Product Change Notice (PCN)

PCN Number: **PCN-0450019R-01**

Product(s) Affected: **PJ-071**

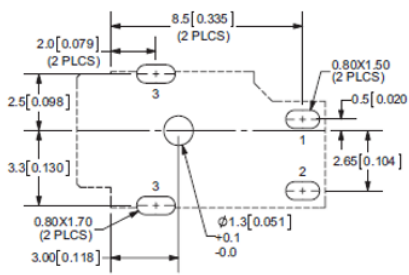
Description of Change: **Material Change. New PCB Dimensions included (pad sizes)**

PREVIOUS CUI DEVICES DETAIL / IMAGE		NEW CUI DEVICES DETAIL / IMAGE																																			
		 <p>Recommended PCB Layout Top View</p>																																			
<table border="1"> <thead> <tr> <th></th> <th>MATERIAL</th> <th>PLATING</th> </tr> </thead> <tbody> <tr> <td>center pin</td> <td>brass</td> <td>tin</td> </tr> <tr> <td>terminal 1</td> <td>brass</td> <td>tin</td> </tr> <tr> <td>terminal 2</td> <td>copper alloy</td> <td>tin</td> </tr> <tr> <td>terminal 3</td> <td>copper alloy</td> <td>tin</td> </tr> <tr> <td>plastic</td> <td>PAB6</td> <td></td> </tr> </tbody> </table>		MATERIAL	PLATING	center pin	brass	tin	terminal 1	brass	tin	terminal 2	copper alloy	tin	terminal 3	copper alloy	tin	plastic	PAB6		<table border="1"> <thead> <tr> <th>DESCRIPTION</th> <th>MATERIAL</th> <th>PLATING/COLOR</th> </tr> </thead> <tbody> <tr> <td>center pin</td> <td>brass</td> <td>tin</td> </tr> <tr> <td>terminal 1</td> <td>brass</td> <td>tin</td> </tr> <tr> <td>terminal 2</td> <td>copper alloy</td> <td>tin</td> </tr> <tr> <td>terminal 3</td> <td>brass</td> <td>tin</td> </tr> <tr> <td>housing</td> <td>PBT (UL94V-0)</td> <td>black</td> </tr> </tbody> </table>	DESCRIPTION	MATERIAL	PLATING/COLOR	center pin	brass	tin	terminal 1	brass	tin	terminal 2	copper alloy	tin	terminal 3	brass	tin	housing	PBT (UL94V-0)	black

MATERIAL	PLATING																																			
center pin	brass	tin																																			
terminal 1	brass	tin																																			
terminal 2	copper alloy	tin																																			
terminal 3	copper alloy	tin																																			
plastic	PAB6																																				
DESCRIPTION	MATERIAL	PLATING/COLOR																																			
center pin	brass	tin																																			
terminal 1	brass	tin																																			
terminal 2	copper alloy	tin																																			
terminal 3	brass	tin																																			
housing	PBT (UL94V-0)	black
